Staff Summary Report

Development Review Commission Date: 09/25/07

SUBJECT: Hold a public hearing for a Zoning Map Amendment and a Development Plan Review for **CAMPUS TOWERS** located at 1215 East Orange Street.

DOCUMENT NAME: DRCr_Campus-Towers_092507

S-1001
 SHEET NO.

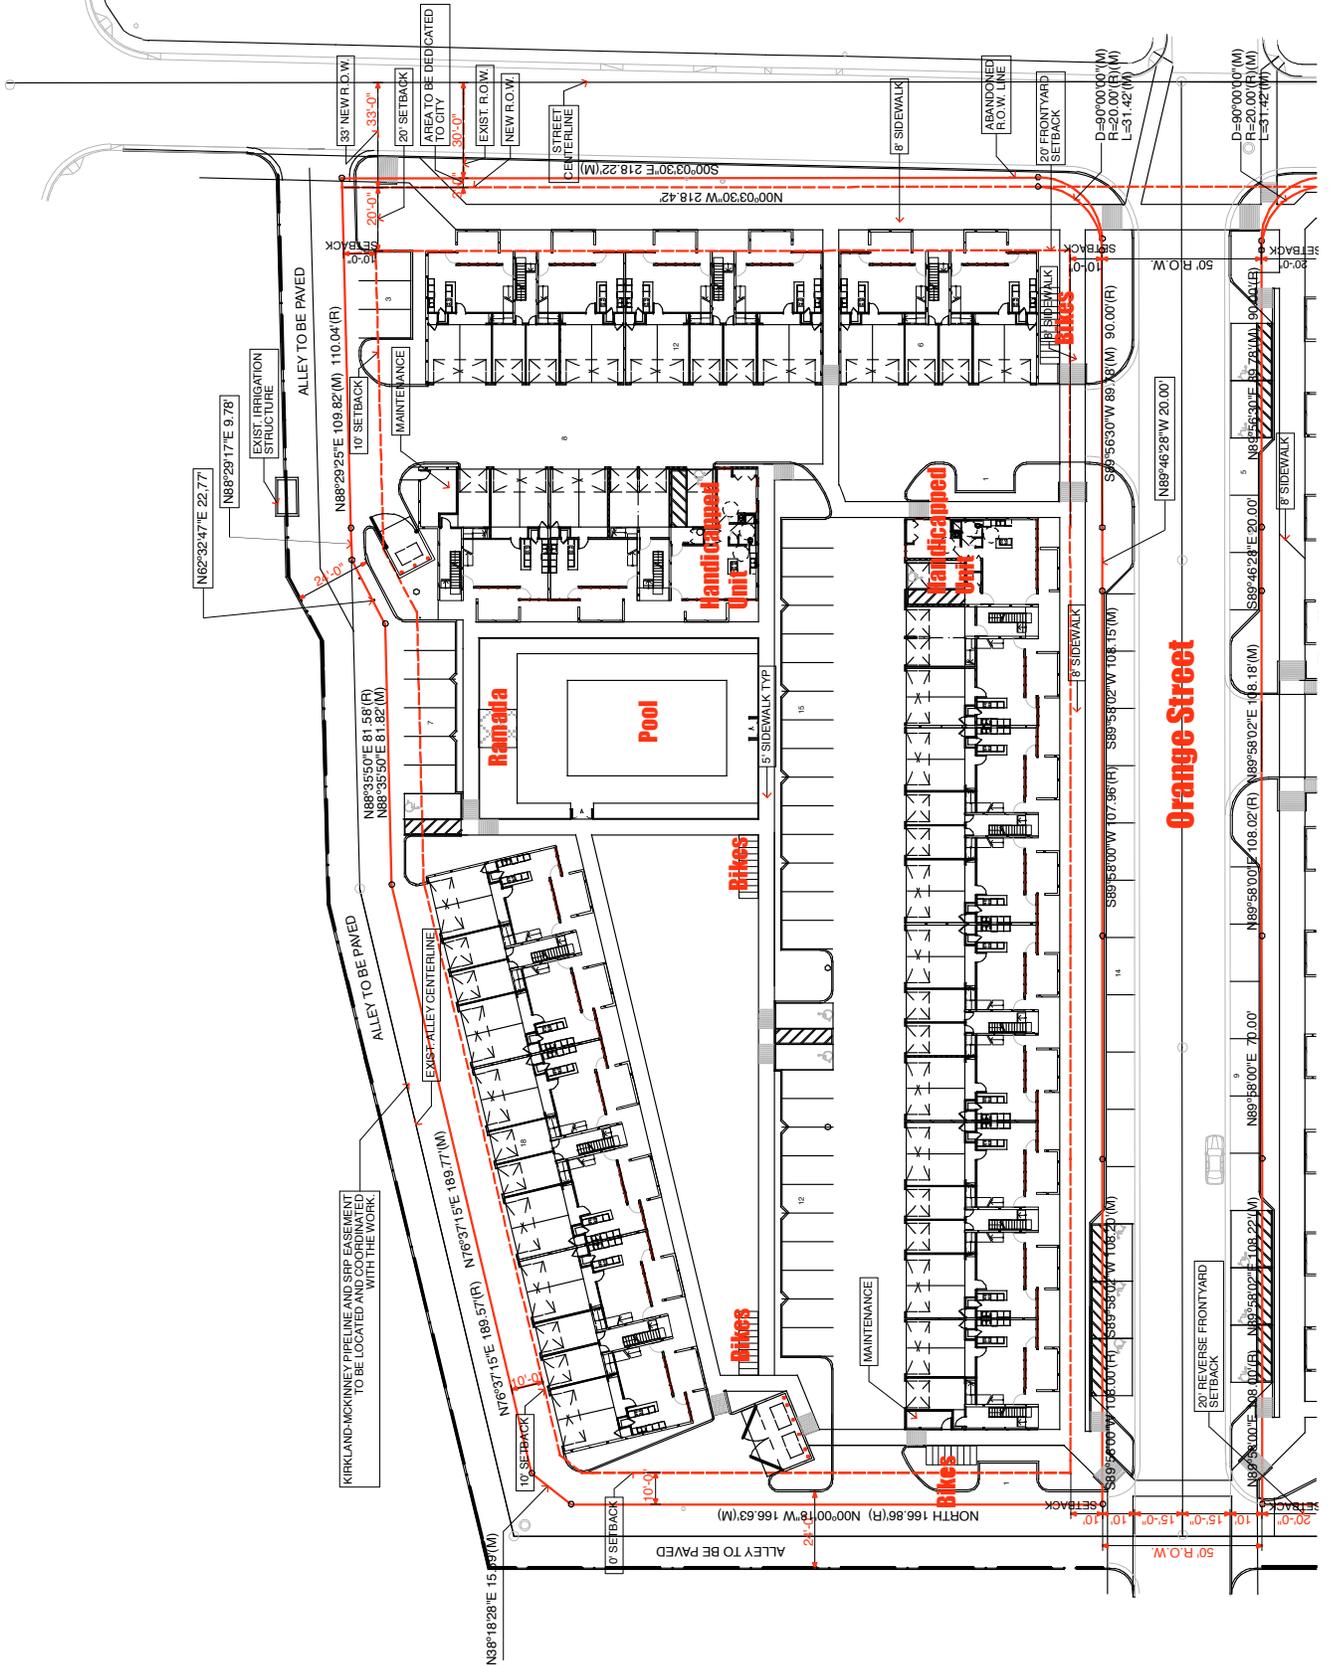
28. Provide additional canopy trees throughout development. Refer to Site Plan Review mark-up, dated 6/20/07, for graphic description of this requirement. In particular, provide required parking landscape island canopy trees in all locations, provide canopy trees along west of Dorsey and on both sides of Orange, and provide a canopy tree row on the north side of the Parcel A triangular green.

S-1002
 SHEET NO.

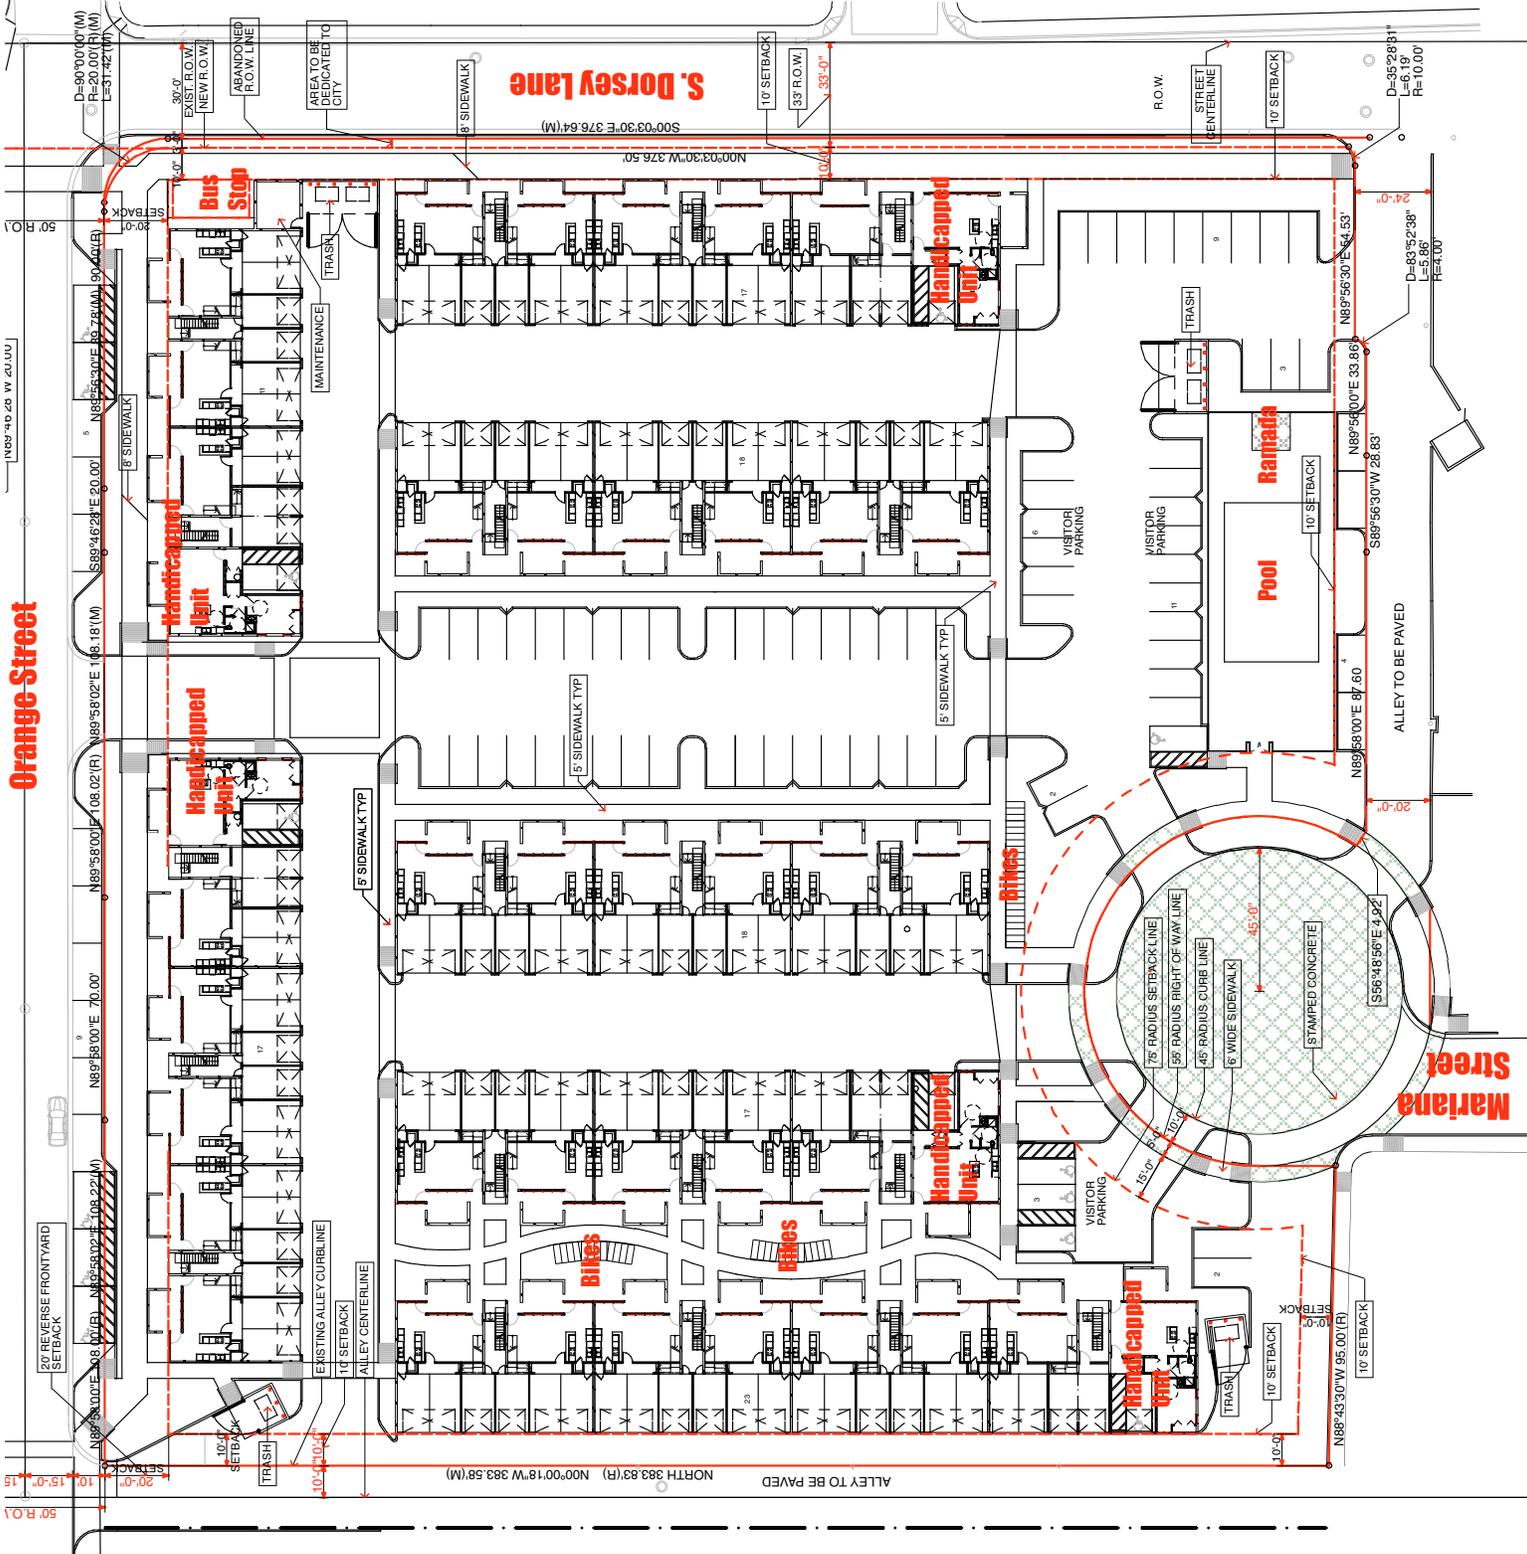
- ` In post-meeting discussion, the architect & Planning Division staff reviewed site plan and determined the south parcel layout can be modified to create a 20' building setback on Dorsey. This setback would be measured from the dedicated right of way line, which is 3' west of the current property line. The increased setback will push the 34' high building facade approximately 6' farther west of where it is now and will allow more room for a landscape buffer.

S-1011
 SHEET NO.

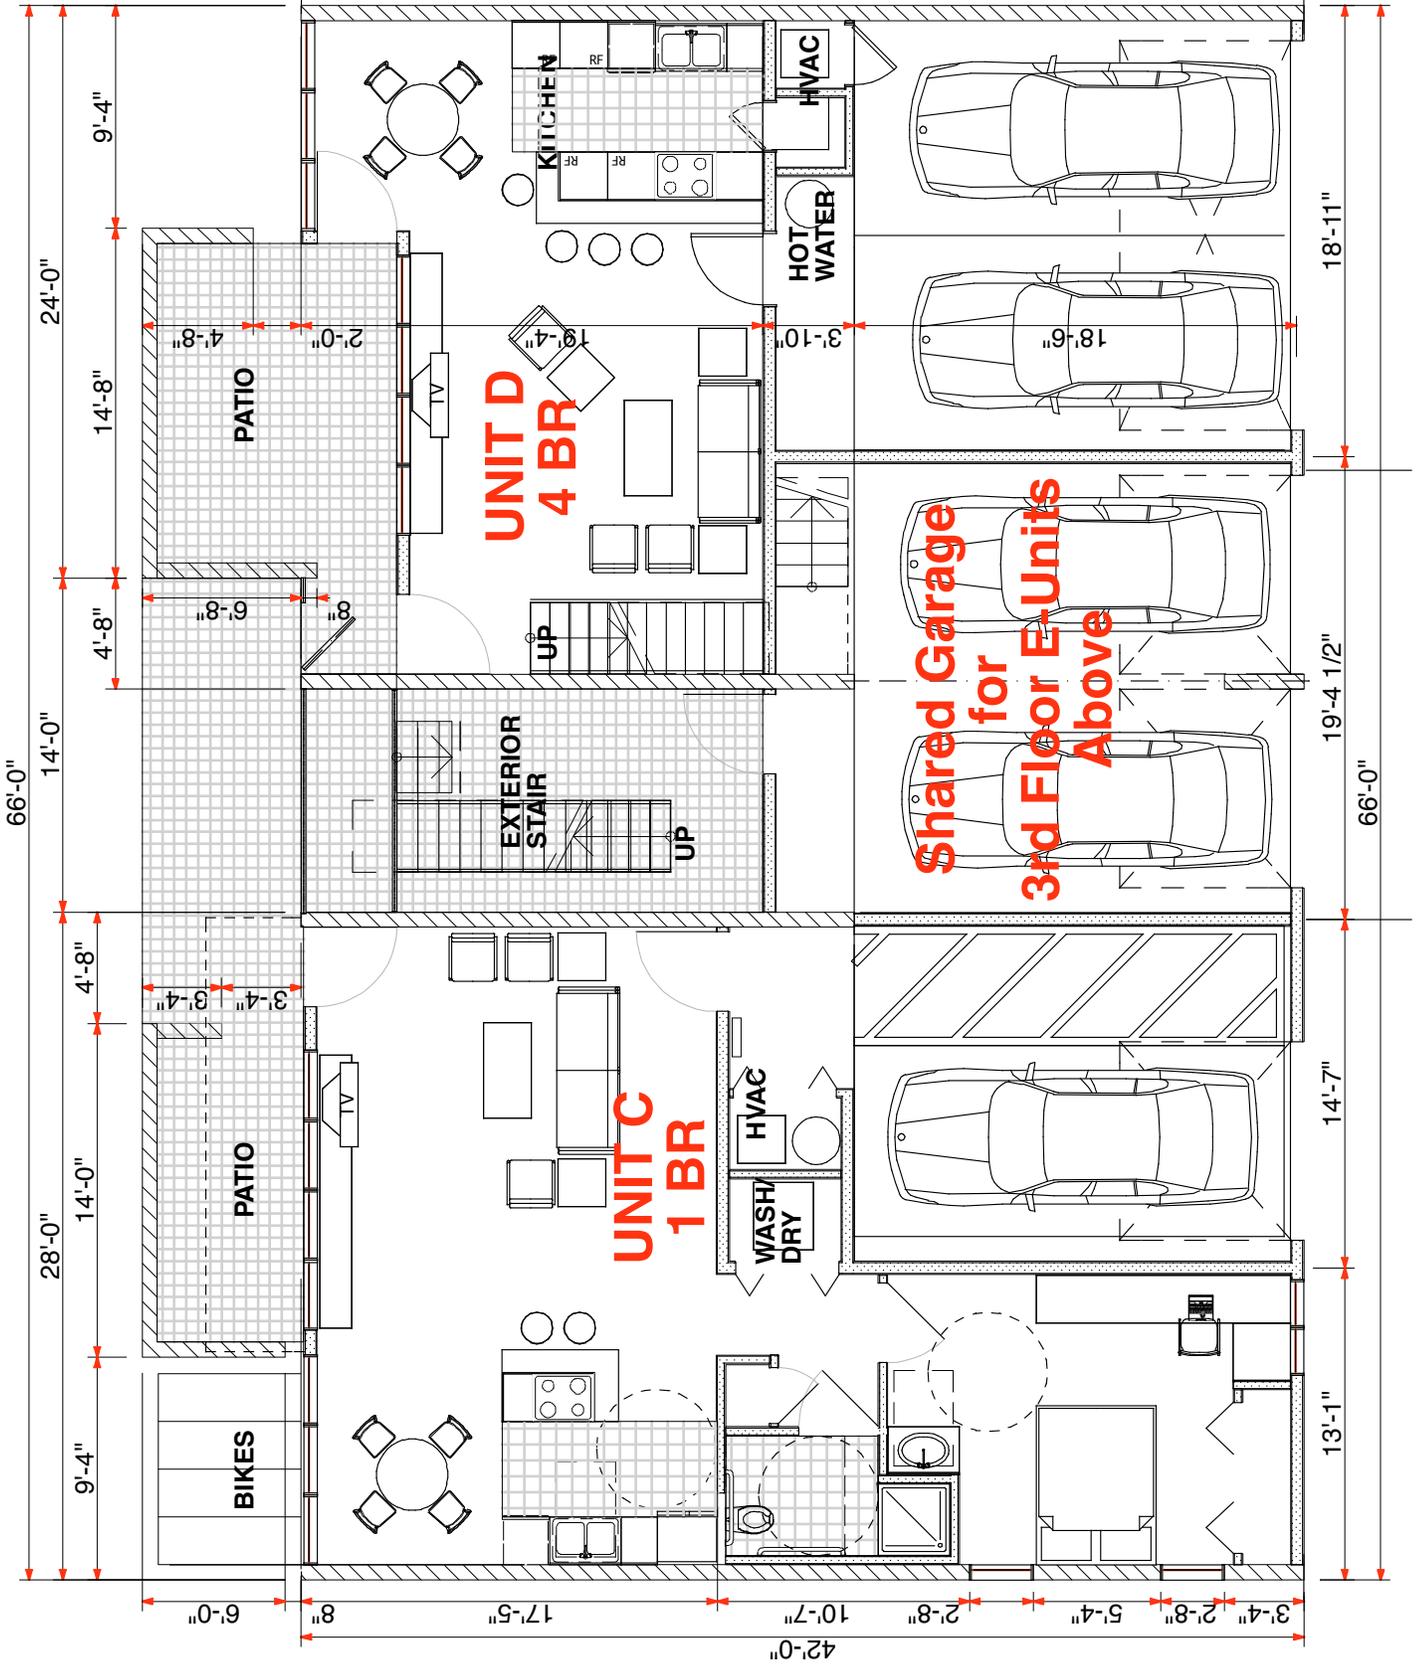
- a. Widen garage door for Dwelling Unit C, typical, to include width of side aisle as well as car space for disabled parking.
 - b. In all unit garages, paint interior wall and overhead surfaces with a highly reflective white color using paint with a minimum light reflectance value of 75 percent.
- Provide a security vision panel at unglazed doors, including at service doors and dwelling entrances (except to rarely accessed equipment rooms). Provide vision panel of high strength plastic or laminated glass, 3" wide, from 43" to 66" above threshold (allow vertical slot window for viewing from a standing or sitting position). Where a vision panel is not desired, equip door with two 360 degree viewers (one for standing, one for sitting) and mount viewers in accordance with A.D.A. provisions.
